Bulletin # SR-5K-1110-01
Release Date: November 9, 2010
Effective Date: November 9, 2010
Supercedes: N/A
Completion Date: December 31, 2010

SAFETY BULLETIN

Ride Manufacturer: Dartron Industries, Inc.	Affected Production Dates: January 1998 – May 2007
Ride Name: Cliff Hanger	Affected Serial #'s: All
Model #: All

Cliff Hanger Bearing Base Ears Reinforcing Plate Installation

Detail of issue:

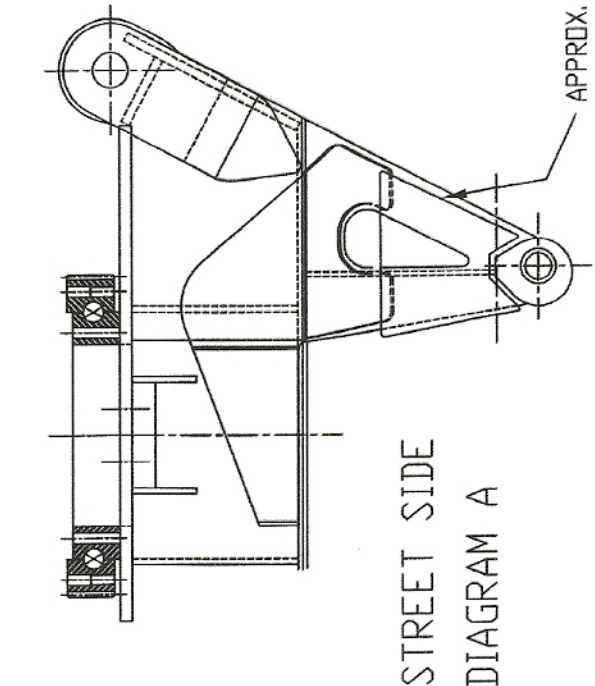
Abstract of Issue: On August 26, 2010; a Dartron Industries, Inc. Cliff Hanger sustained a failure in the material of the lower ears of the bearing base. There were no injuries.

Reason for release: To insure that all Cliff Hanger rides install reinforcement plates in a critical area of support for the bearing base. A failure in this area could result in injuries. Installation procedures are included.

1. The ride must be at least partially set-up to perform this operation. The front car racks must be down and the wheel must be pinned together.
2. Material required will include a support for the bearing base such as blocking stacked on the ground.
3. Using the ride hydraulics, the boom should be raised off the Boom Rest Pad to provide a comfortable working height for the repair person. This height should be approximately 3 feet.
4. Support must be provided under the Bearing Base to prevent the Boom from dropping during the repair process. This support can be blocking or similar material stacked on the ground under the Bearing Base. The support should be provided directly under the Pivot Pin Ears where the Drag Link Pins to the Bearing Base. **Do Not Place this Support Under the 6" Square Drag-Link Tube – Damage Will Occur.**

Another method of supporting the Bearing Base is to build a cross member bridge. The cross member bridge can be supported across the trailer frame behind the boom rest and will support the Bearing Base Pivot Pin Ears.
